Adamstown Boulevard

Phase 1 Road Safety Audit

Adamstown Station & Boulevard Ltd

April 2022

Figure 2-1 – No Pedestrian Crossing Provision

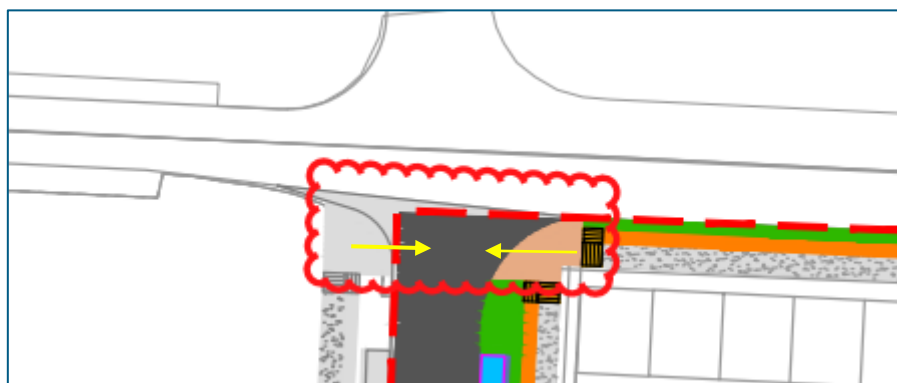
There is no crossing provision for pedestrians trying to cross East – West at the location shown in Figure 2-1. This may lead to pedestrians trying to cross the road in a location which is unsafe to do so and may result in them being struck by a vehicle.

The designer should provide appropriate crossing facilities for pedestrians to cross at the junction.

Figure 2-4 – Example of Grass verges Separating Footpath and Parking Bays

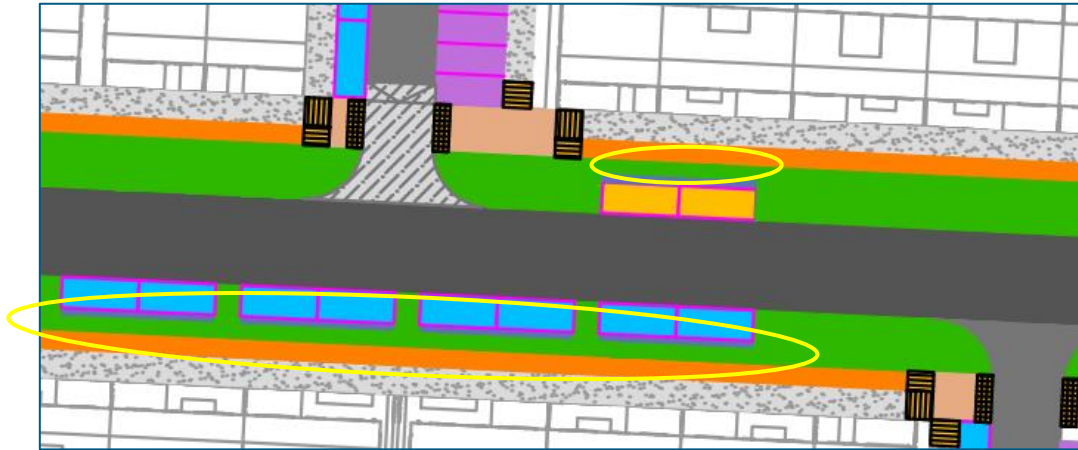
The proposed scheme shows parking bays which are separated from the footpath with a grass verge as shown in Figure 2-4. This could lead to pedestrians slipping and falling on the grass particularly in wet conditions or pedestrians may be forced to use the carriageway to access the parking spaces and possibly result in them being struck by a vehicle.

The designer should ensure that safe access to all parking areas is provided throughout the scheme.

Figure 2-5 – Signalised Junction No.1

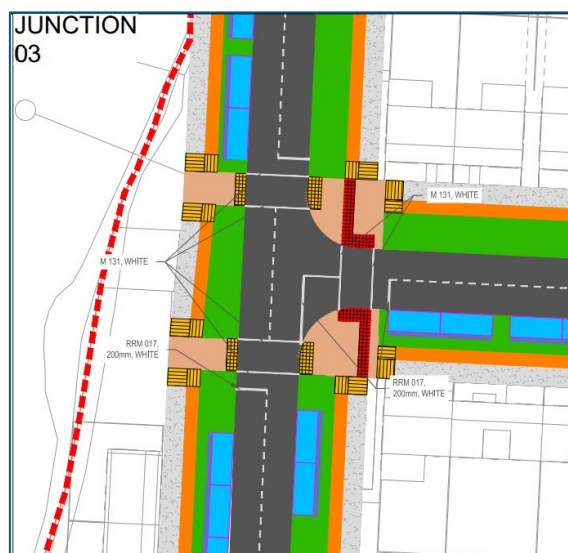
The proposals indicate courtesy crossings on the main north-south streets for the scheme. It appears unlikely that these will adequately allow for safe crossing of these roads and may lead to conflict with pedestrians and vehicles. Additionally the side road shows a controlled crossing, drivers may move on a green signal on the side road and enter the main road when it is unsafe to proceed. This may lead to shunt and side-impact conflict.

The designer should review the junction strategy ensuring these will cater for the likely demand, provide adequate control and not lead to potential confusion for both pedestrian and vehicles users.

Figure 2-8 - Visibility Issue Location No.1

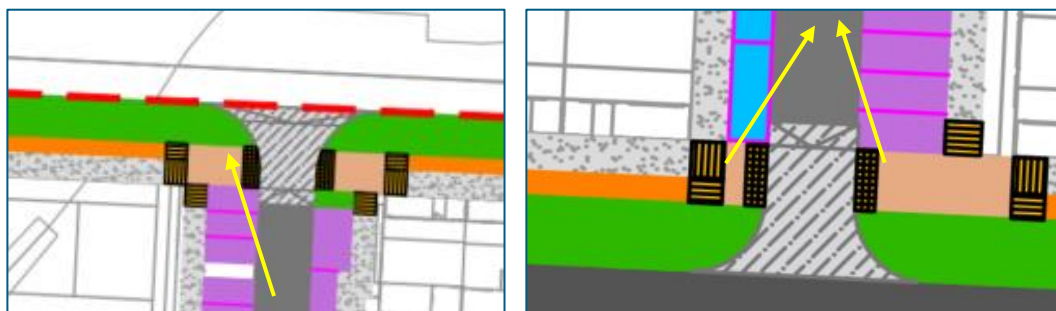
A number of proposed uncontrolled crossings will likely have visibility issues due to parked vehicles directly beside the crossing points. Footpath users particularly smaller individuals including children are unlikely to be able to see vehicles and similarly vehicles will be unable to see children that are attempting to cross. Poor visibility may lead to pedestrians trying to cross the carriageway without being sure it is safe to do so and could lead to them being struck by an oncoming vehicle.

The designer should relocate/set-back the parking to help improve visibility at the proposed uncontrolled crossings.
